NAVAL AIR STATION FORT WORTH JRB CARSWELL FIELD TEXAS

FINAL PHASE II RFI WORK PLAN AREA OF CONCERN 13 NAS FORT WORTH JRB, TEXAS

RESPONSES TO COMMENTS: DRAFT PHASE II RFI WORK PLAN AREA OF CONCERN 13 NAS FORT WORTH JRB, TEXAS

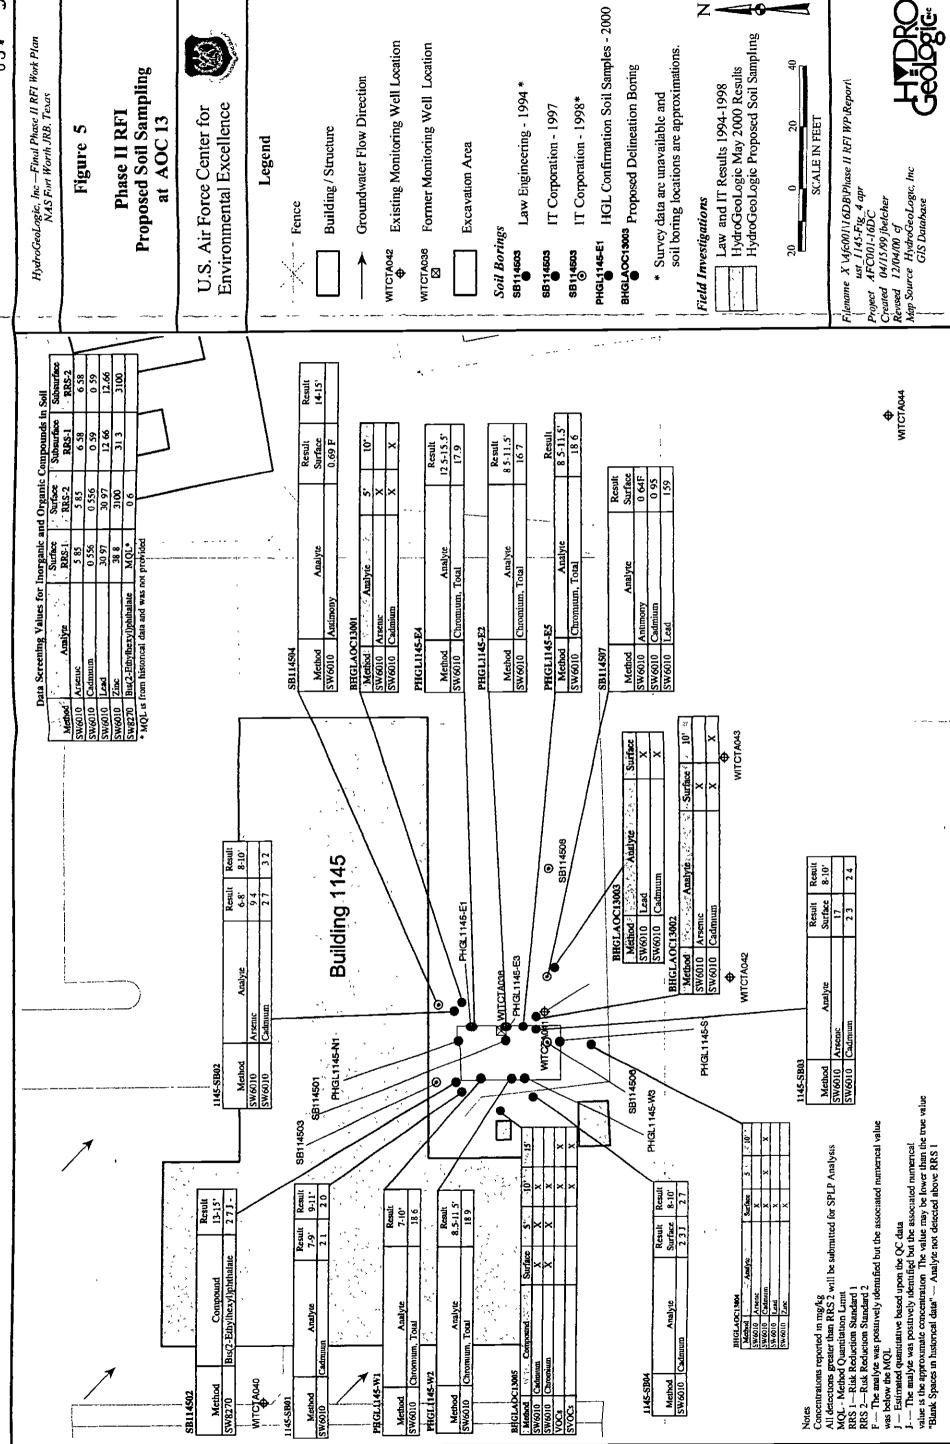
Comment 4 Figure 3, Data Screening Values for Groundwater: Please show the actual MQL values in the table.

Response HydroGeoLogic will attempt to identify the specific MQLs in the RFI Report, however this may be an impossible task since MQLs vary by laboratory, and sometimes by year. These analytical results were generated by a contractor other than HydroGeoLogic.
